**Development and Management Plan Update No. 1
Underground Utility Design and Water Balance Revisions
PSEG Power Connecticut LLC
Bridgeport Harbor Station Unit 5 Combined Cycle Project
Petition No. 1218**

**Connecticut Siting Council
Development and Management Plan Update No. 1
Combined Cycle Generating Facility**

**Bridgeport Harbor Station Unit 5
Bridgeport, Connecticut**

Design Revisions

644911-FD002 Sheet 001 Water System Process Flow Diagram - Sheet 1 of 2
644911-FD002 Sheet 002 Water System Water Mass Balance - Sheet 2 of 2

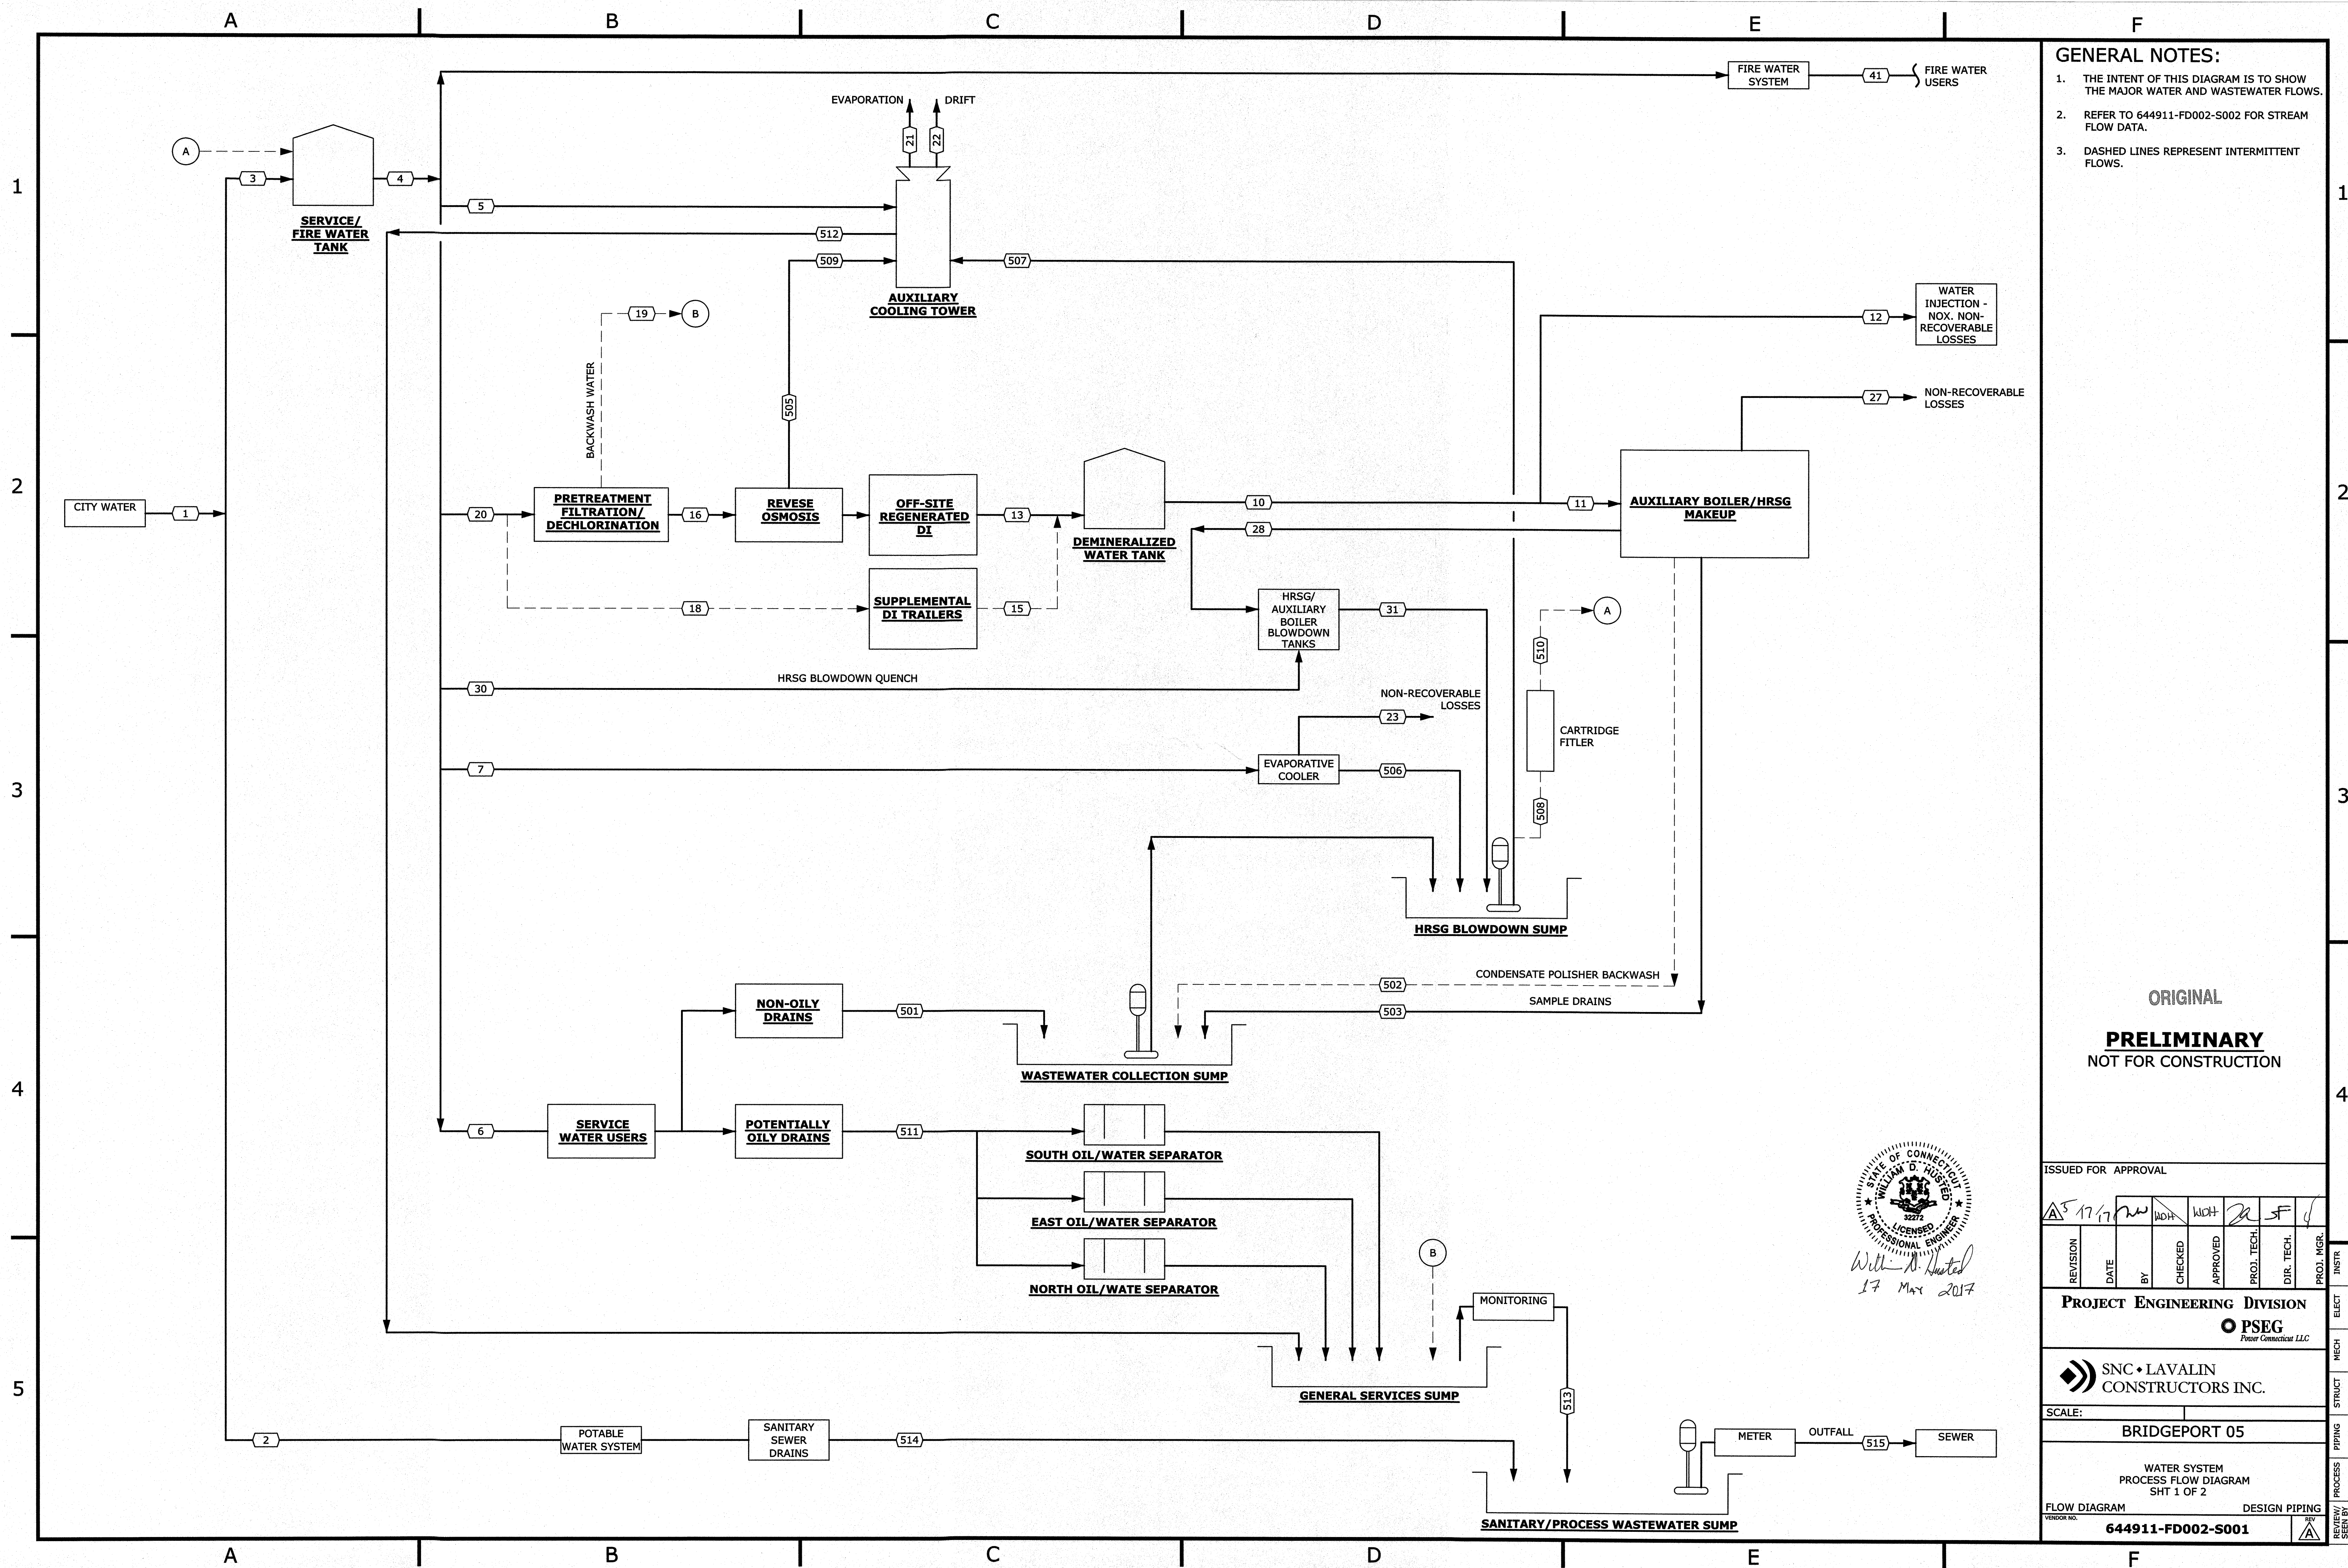
Similar to the changes in the underground design detailed above and in Exhibit 1, PSEG and SNCL have also conducted a review of the site water balance with the objective of reducing freshwater requirements and wastewater discharges, where possible, for the various plant operating scenarios. The revised water balance diagram and table of operating cases is included as Exhibit 2. The prior water balance was provided in D&MP Phase 2, Exhibit 4.

The proposed changes, while collectively not significant, more accurately represent the anticipated plant operating scenarios. The water balance includes flow path rerouting to accommodate the following:

1. Removing the discharge from the oil water separators (OWS) to the cooling tower;
2. Eliminating the discharge of minor stormwater quantities from exterior containments to the City Water Pollution Control Authority (WPCA) collection system;
3. Improvements in the ability to reuse / reprocess water under certain conditions.

The water balance diagram has been optimized during final design to provide additional operational flexibility, reduce cooling tower and circulating water system fouling potential, and incorporate seasonal variations in cooling tower evaporation rates. The optimized water balance results in a minor reduction in average annual facility water supply requirements and maintains process wastewater discharge flow and quality characteristics within allowable ranges for discharge to the sewer.
